PLAN COMMISSION AGENDA
January 14, 2019

Eau Claire Plan Commission 1/14/19 Agenda Items

STAFF REPORT

ADVANCED ENGINEERING CONCEPTS
1360 INTERNATIONAL DR.
EAU CLAIRE, WI 54701
PH 715-552-0330
INFO@RLS-AEC.COM
COPYRIGHT 2018, AEC LLC.

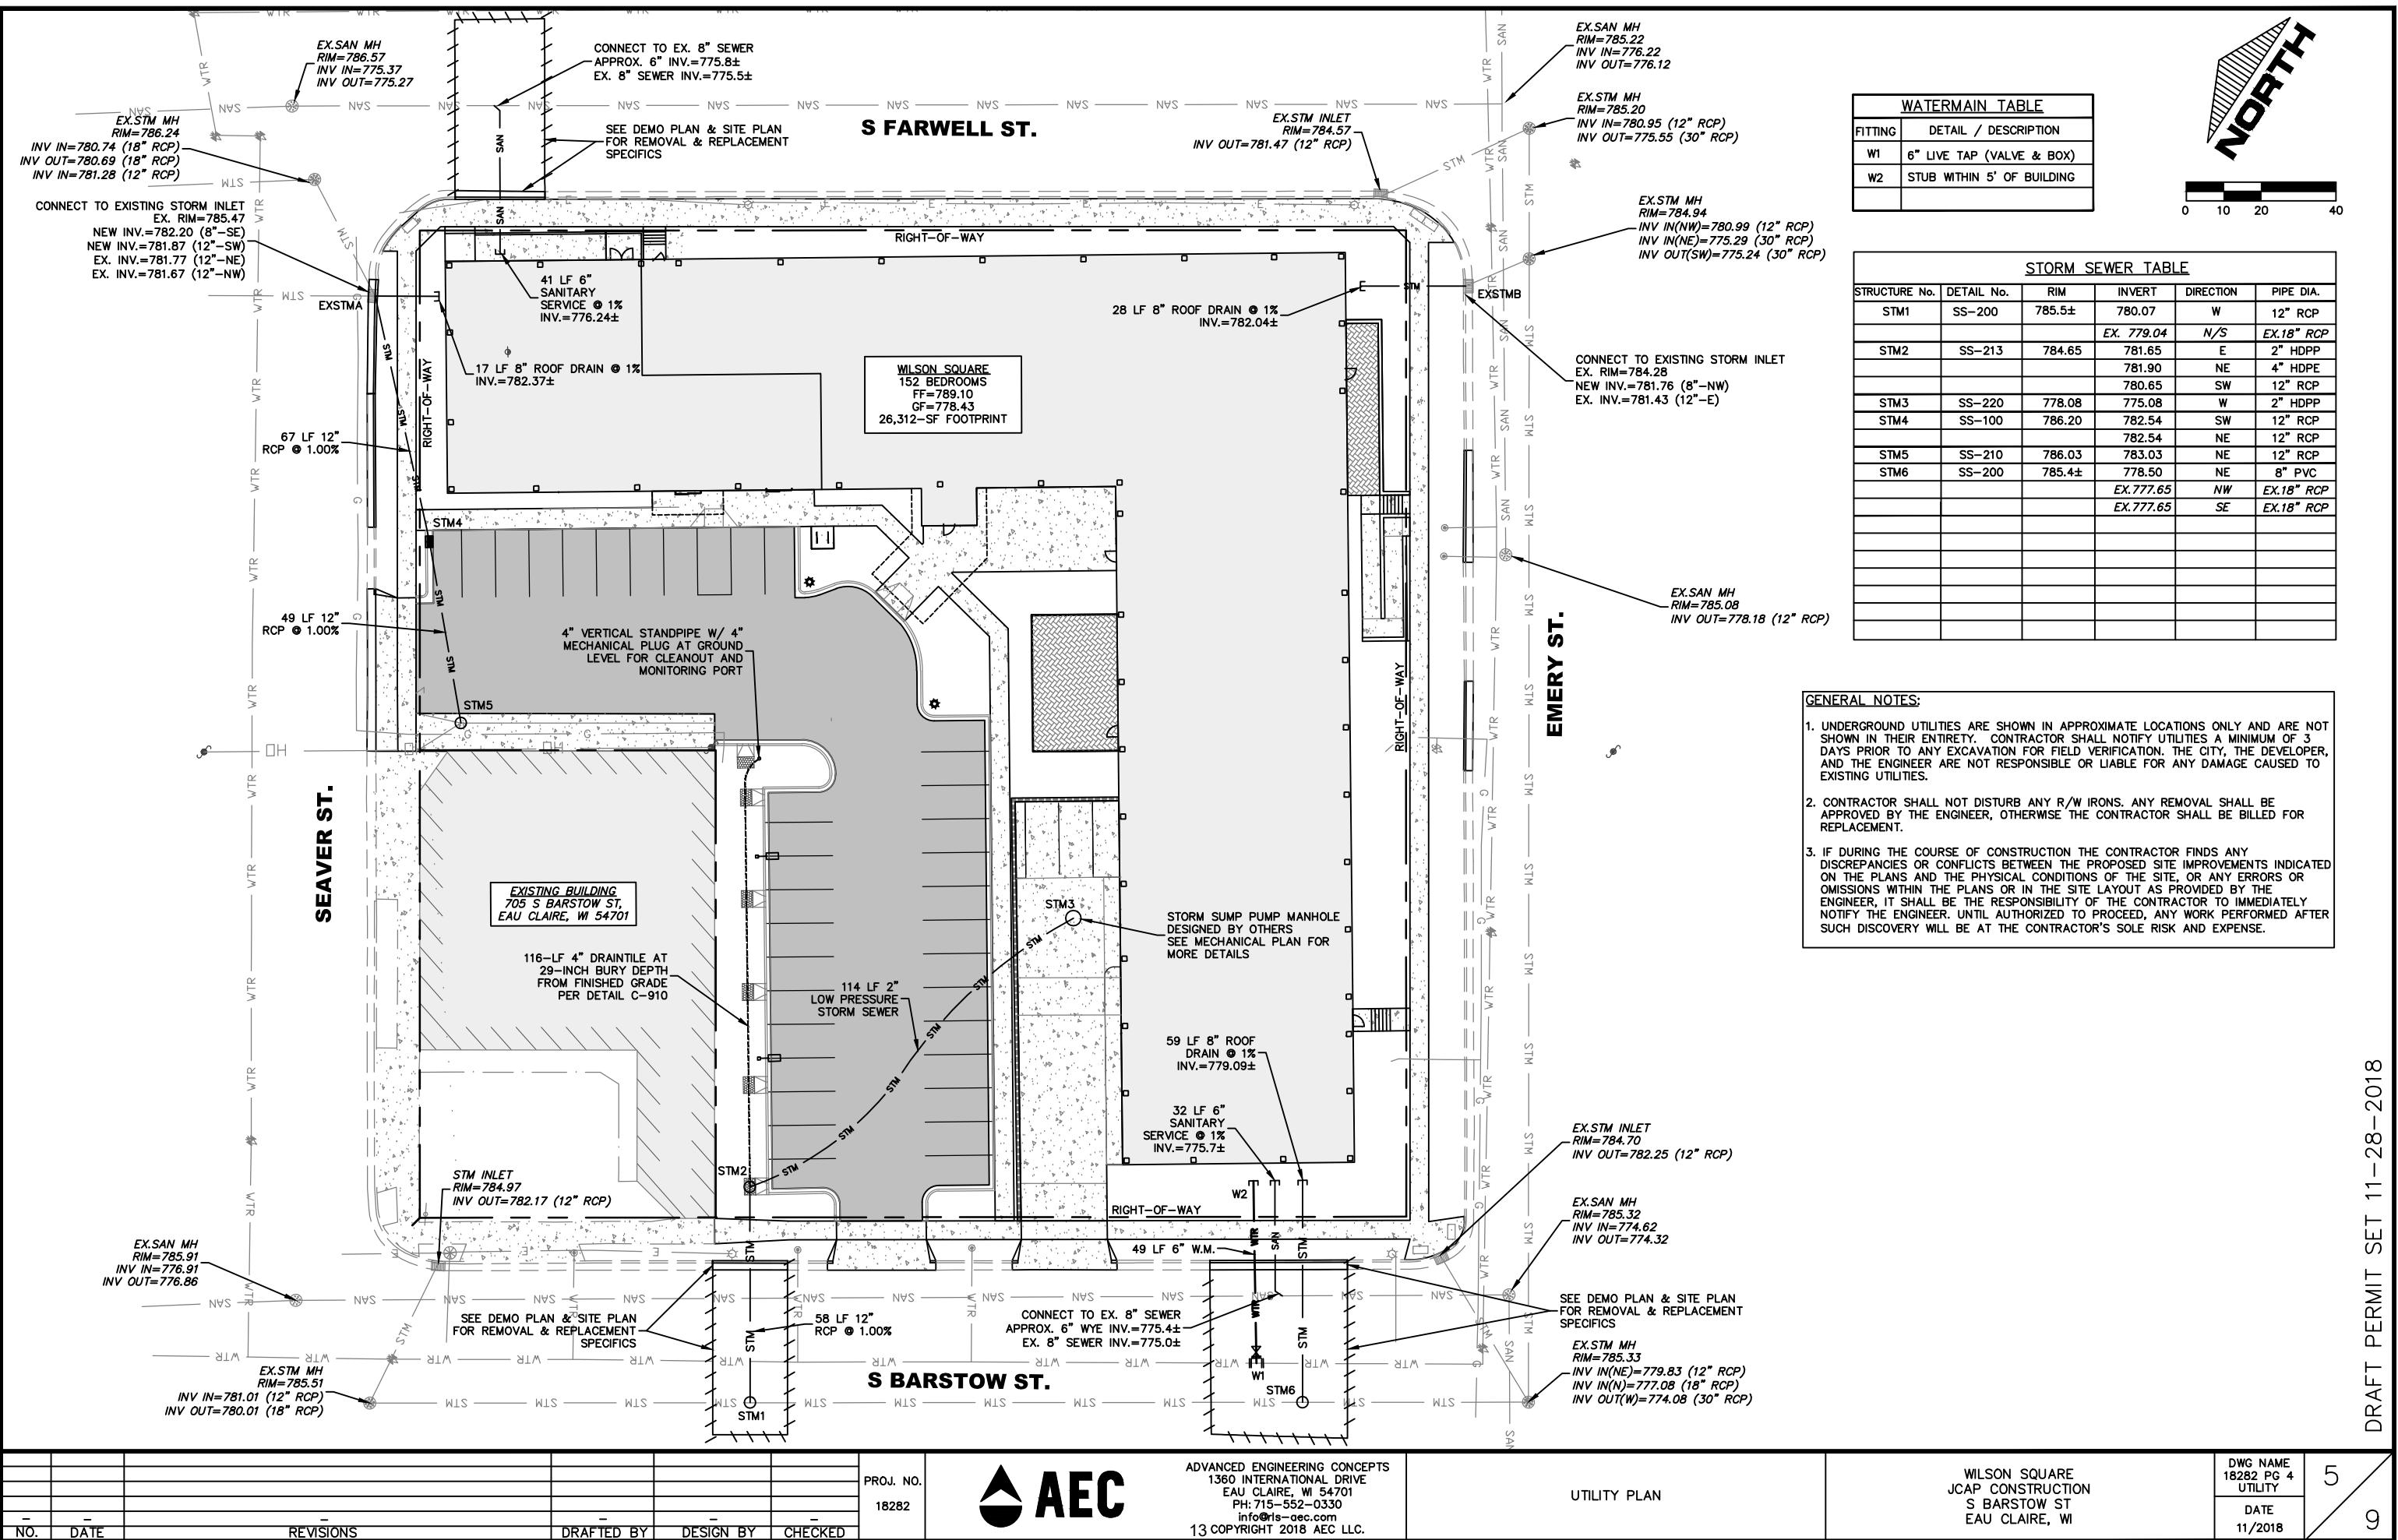
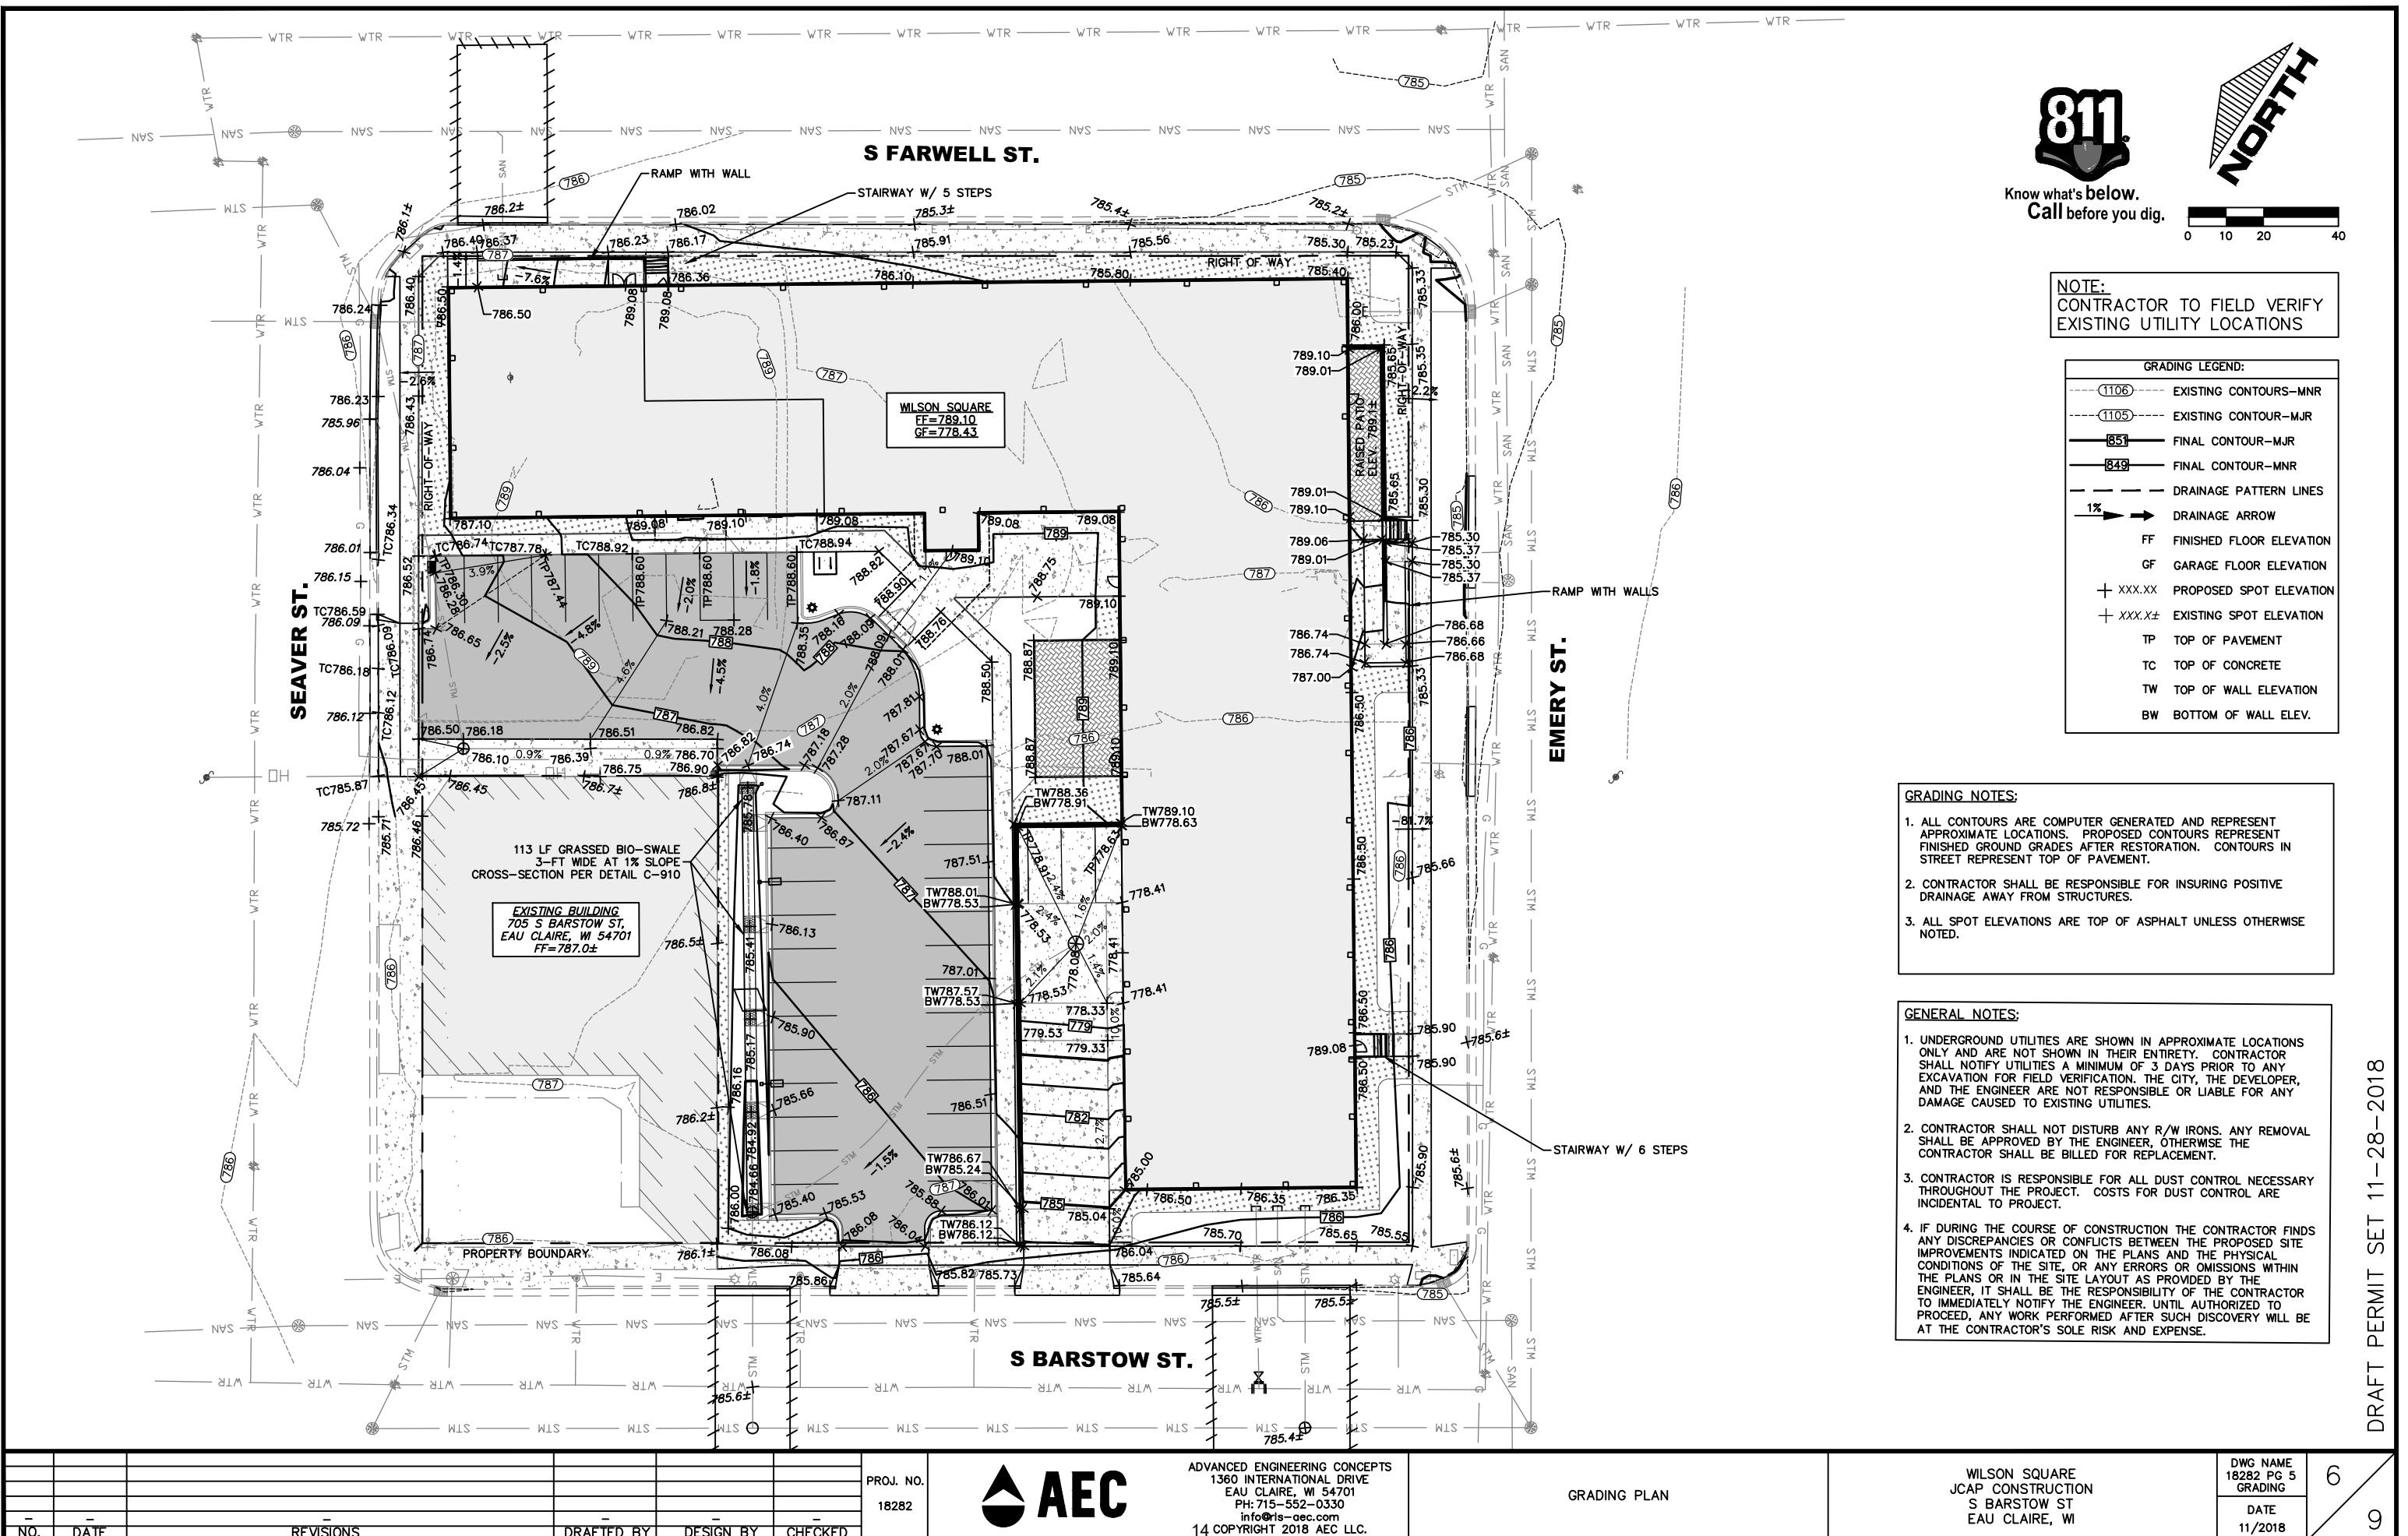
Storm water best management practices (BMP's) are required to improve runoff water quality. A bio-filtration swale is proposed as the water quality BMP. Materials submitted with the site plan indicate that in this application these units are calculated to remove approximately 45% of Total Suspended Solids. The threshold for redevelopment BMP's identified in NR151 is a 40% reduction in Total Suspended Solids. The proposed facility will meet that requirement for the site. The proposed method of handling storm water runoff is to sheet flow runoff across the parking lot into a grass bio-filtration swale that discharges to the drainage system in South Barstow Street. Storm water runoff from the rooftops will be piped directly into the public storm sewer system via three separate connections. The proposed BMP is adjacent to an existing basement on an adjacent parcel. Measures will need to be taken to protect the adjacent structure from runoff infiltrating from the BMP. Protective measures may include sealing the exterior wall of the existing foundation, extending the infiltration media below the WQ BMP to an elevation below the basement slab and the frost line, lining the BMP below the engineered media and drain, a combination of these measures, or other measures designed for similar intent.

Parking related to the commercial development will have access to a surface parking lot from both Seaver Street and South Barstow Street. The plan proposes a 24-foot curb cut on each street for driveway access to the surface parking lot. A second 23-foot curb cut is proposed on South Barstow Street, east of the surface lot driveway to access the proposed underground parking. The driveway approach to Seaver Street needs to align with the existing public alley. Using the alley as access to the parking lot is a permitted use, however, it will be treated as a driveway within the alley (similar to a driveway crossing a boulevard) and will be the responsibility of the parking lot owner to maintain the pavement, clear snow, and replace the pavement as needed.

1. City of Eau Claire Engineering Department approval of drainage calculations and drainage plan.
2. Details showing method to protect the adjacent basement from water quality BMP infiltration.
